ENCLOSURE 4

PROPOSED CHANGE TECHNICAL SPECIFICATION PAGES

H.B. ROBINSON Unit #2  
Carolina  
Power & Light Company  
Technical Specifications

FIGURE  
3.10-1

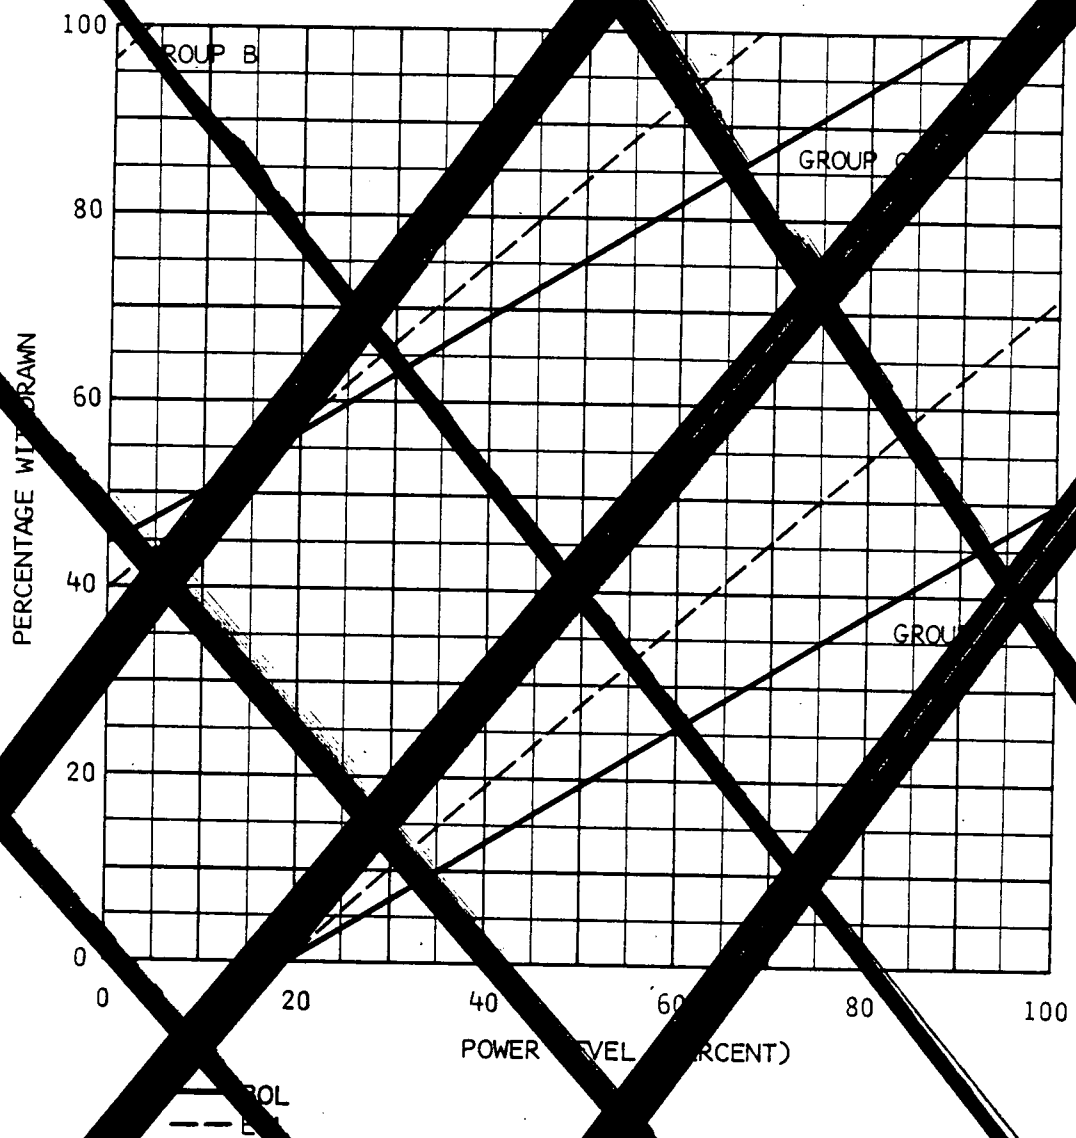
3.10.1.3 When the reactor is critical, except for physics tests and full length control rod exercises, the control rods shall be no further inserted than the limits shown by the solid lines on Figure 3.10-1 for three-loop operation. ← limited in physical insertion as specified in the COLR.

3.10.1.4 At 50 percent of the cycle as defined by burnup, the limits shall be adjusted to the end-of-core values as shown by the dotted lines on Figure 3.10-1. ← specified in the COLR.

FIGURE 3.10-1 DELETED

The control rod insertion limits are specified in the CORE OPERATING LIMITS REPORT (COLR) and are appropriately chosen to meet the shutdown requirements shown in Figure 3.10-2.

FIGURE 3.10-3 NORMALIZED AXIAL DEPENDENCE FACTOR FOR  $F_q$  VERSUS ELEVATION  
(PEAK  $F_q = 2.32$ )

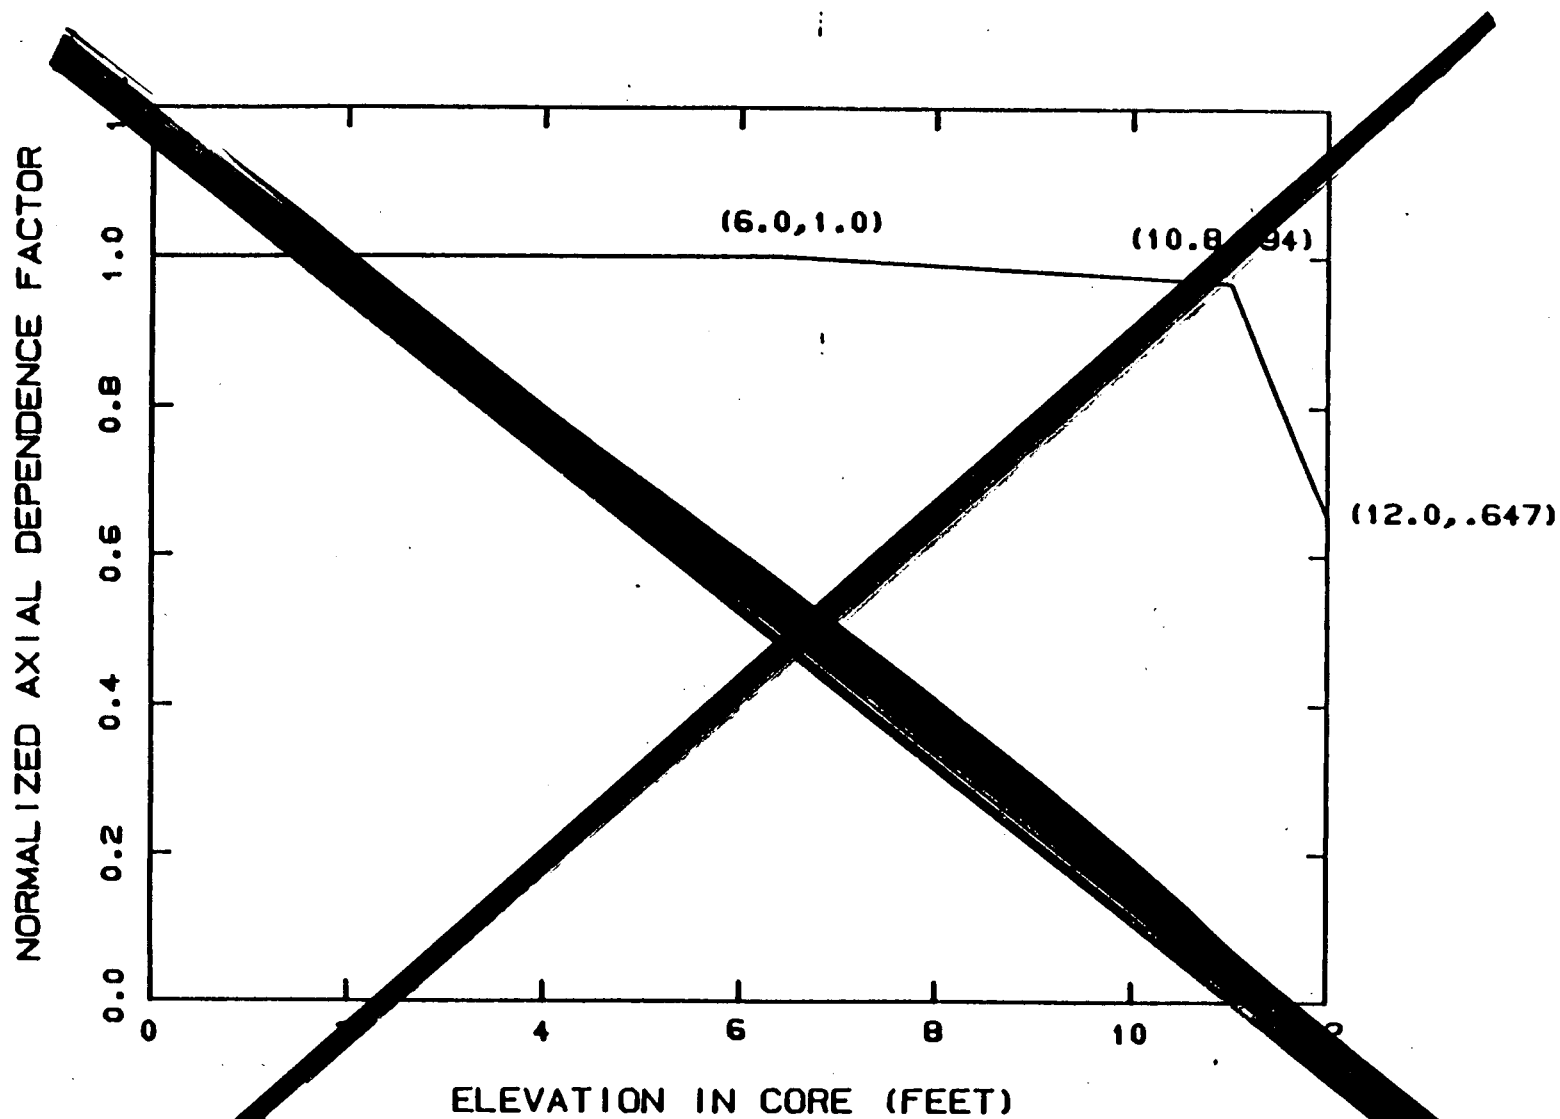
*The  $V(Z)$  axial variation function and  $K(Z)$  functions are specified in the COLR.*

FIGURES 3.10-3 THROUGH 3.10-5 DELETED

the normalized  $F_Q(Z)$  as a function of core height specified in the CORE OPERATING LIMITS REPORT (COLR).  $F_Q^{RTP}$  is the  $F_Q$  limit at RATED THERMAL POWER (RTP),  $F_{\Delta H}^{RTP}$  is the  $F_{\Delta H}$  limit at RATED THERMAL POWER,  $PF_{\Delta H}$  is the Power Factor Multiplier for  $F_{\Delta H}^{RTP}$ .  $F_Q^{RTP}$ ,  $F_{\Delta H}^{RTP}$ , and  $PF_{\Delta H}$  are specified in the COLR.

Figure 3.10-4

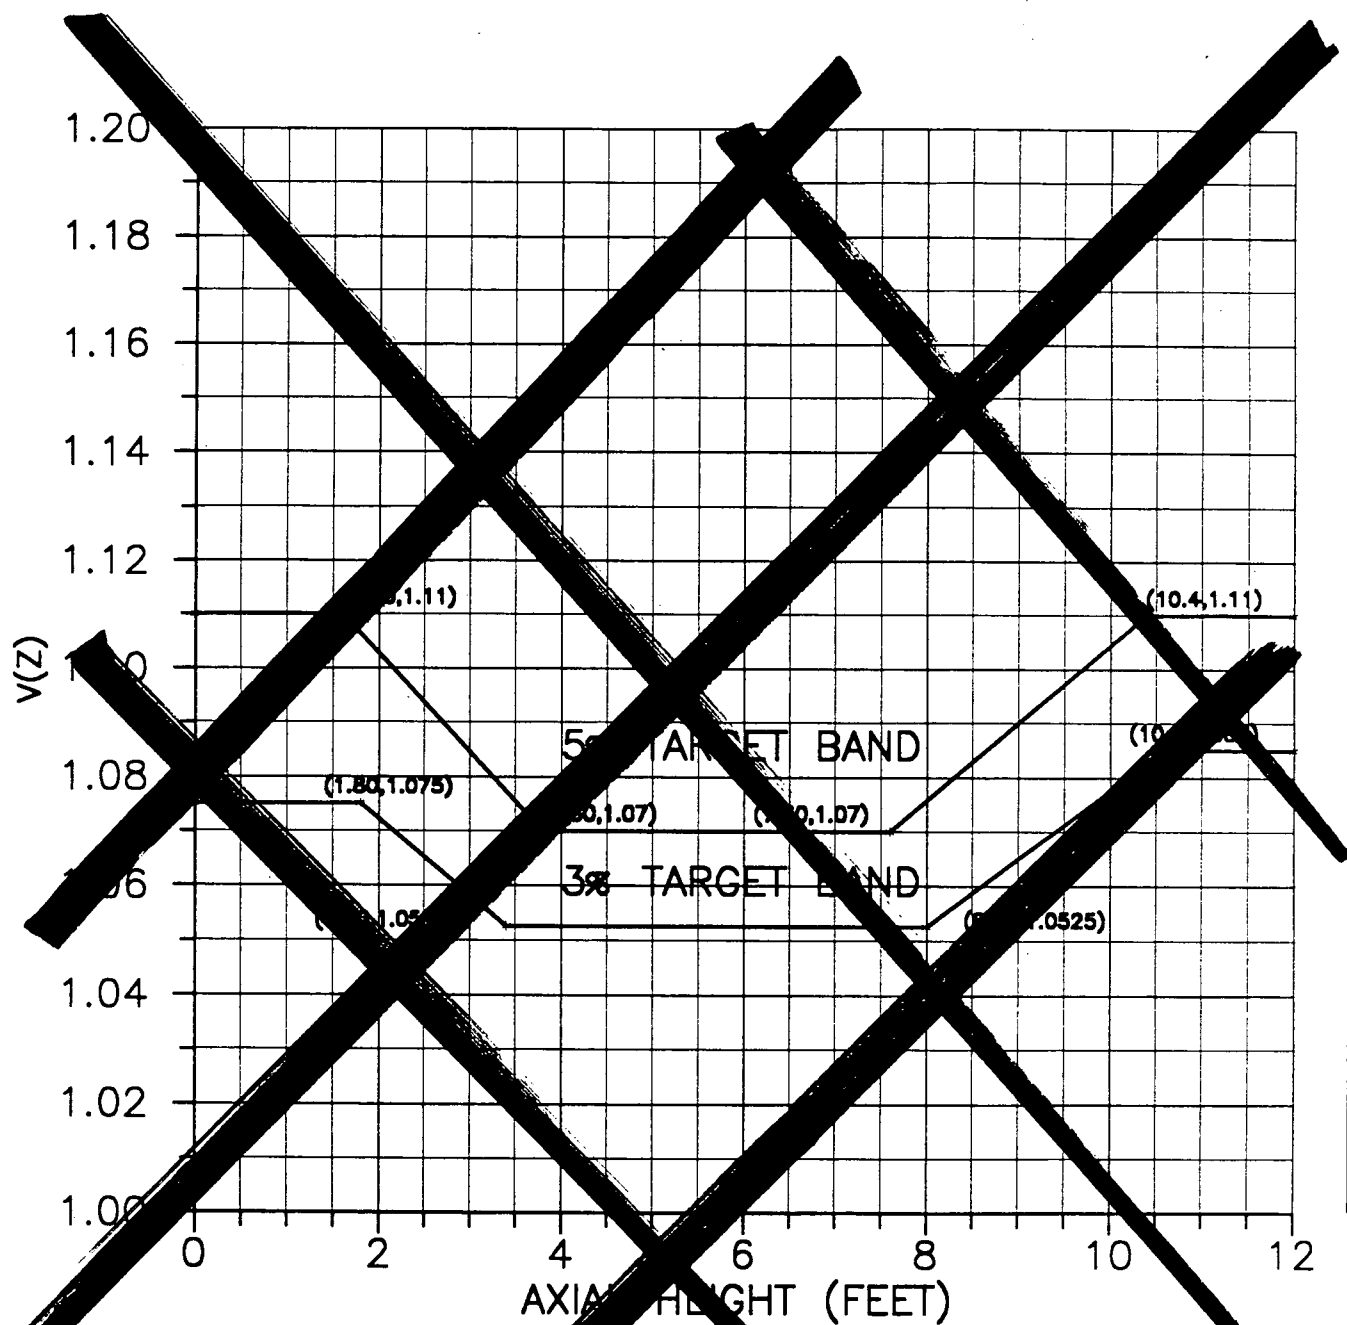
where  $V(Z)$  is defined in Figure 3.10-4 which corresponds to the target band and  $P > 0.5$ . *specified in the COLR.*

**FIGURE DELETED**

Figure 3.10-5

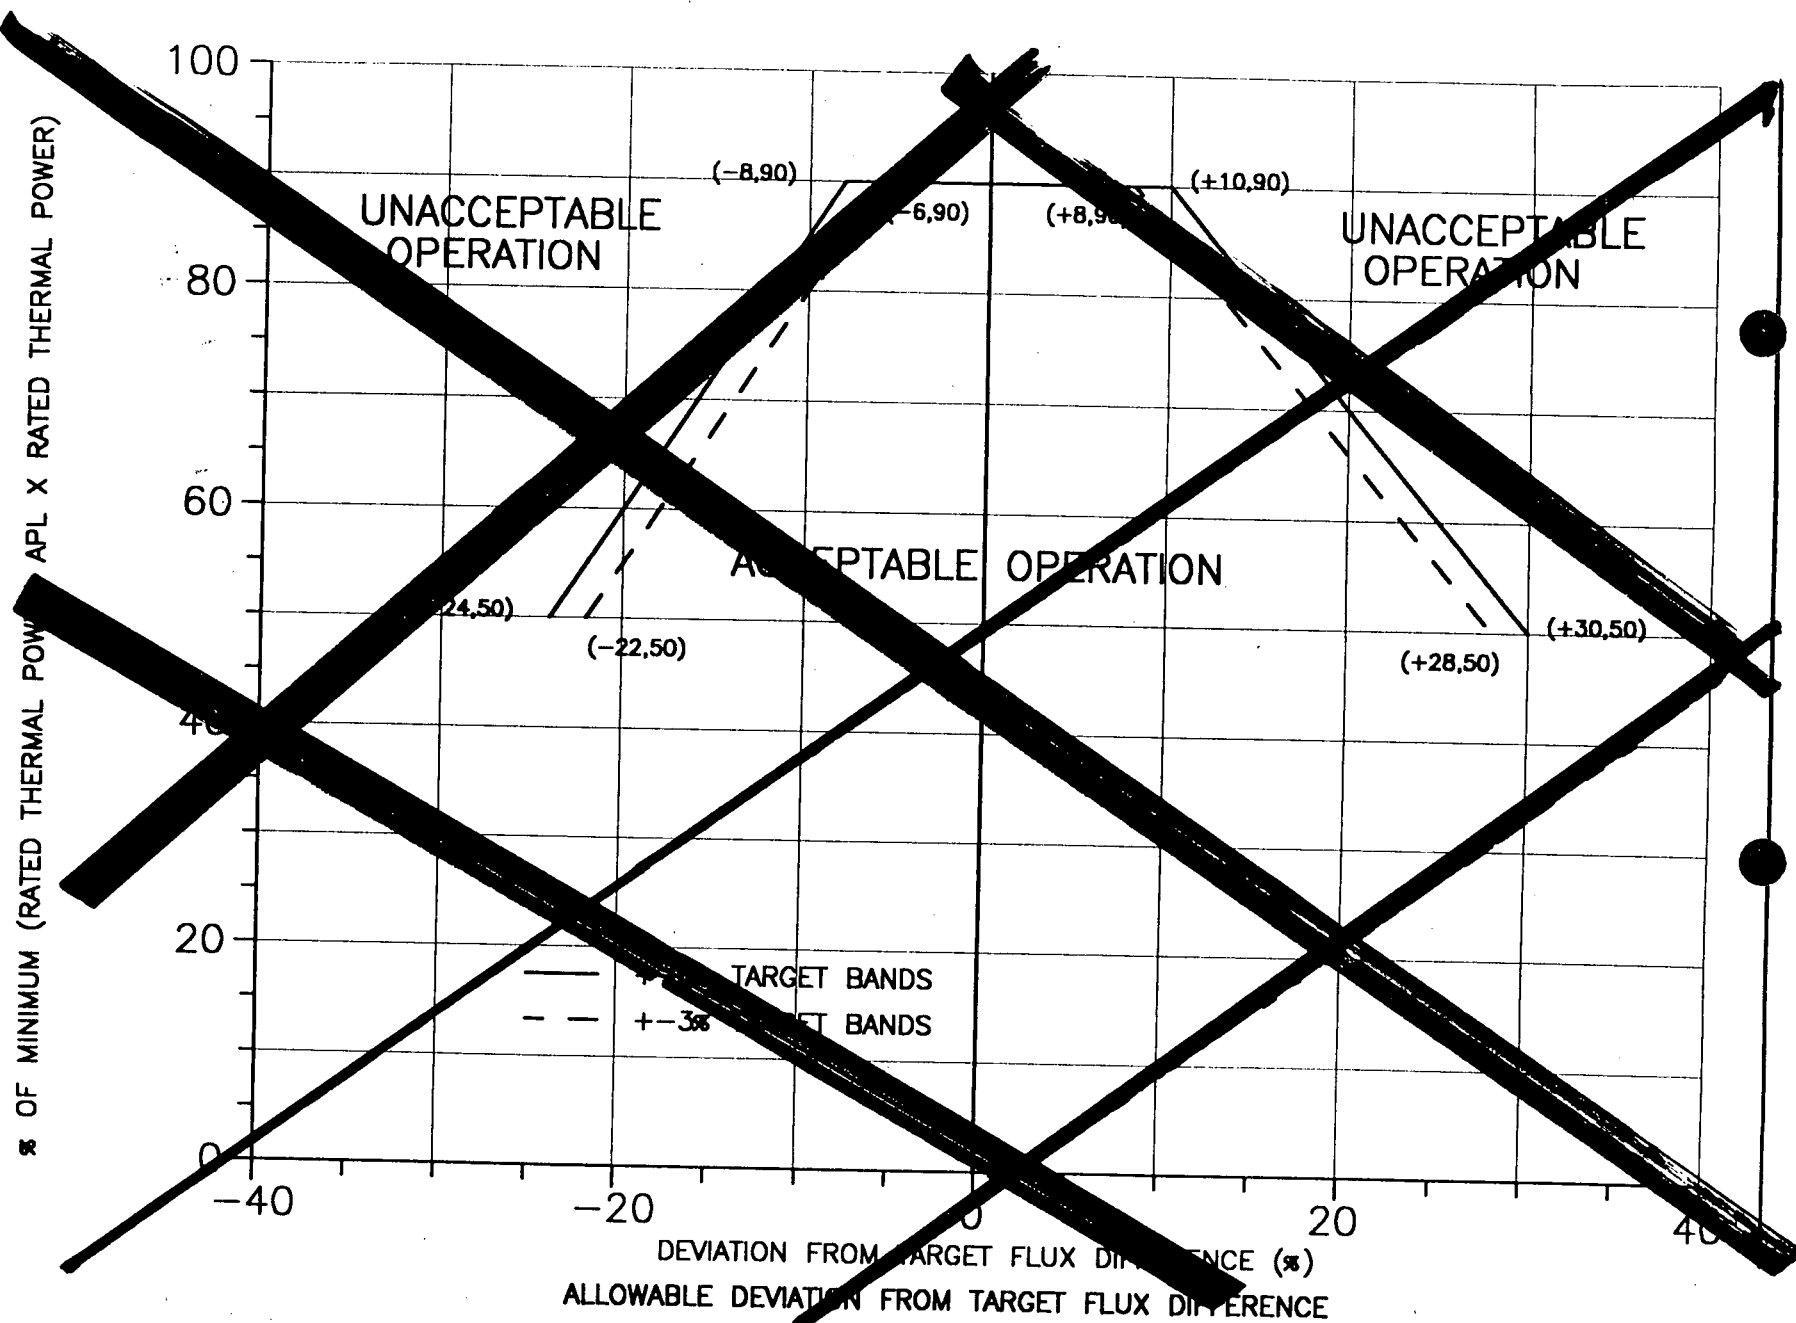
- b. at power levels less than 90 percent of rated power or  $0.9 \times \text{APL}$  (whichever is less) provided the indicated axial flux difference does not exceed the limits shown in Figure 3.10-5. *specified in the COLR.*

3.10.2.11 The axial flux difference target band about the target axial flux difference shall be determined in conjunction with the measurement of  $F_Q(Z)$  as specified in 3.10.2.1.1. The allowable values of the target band are shown in Figure 3.10-5. *specified in the COLR.* Redefinition of the target band from more restrictive to less restrictive ranges between determinations of the target axial flux difference is allowed when appropriate redefinitions of APL are made. Redefinition of the target band from less restrictive to more restrictive ranges is allowed only in conjunction with the determination of a new target axial flux difference.

**FIGURE DELETED**
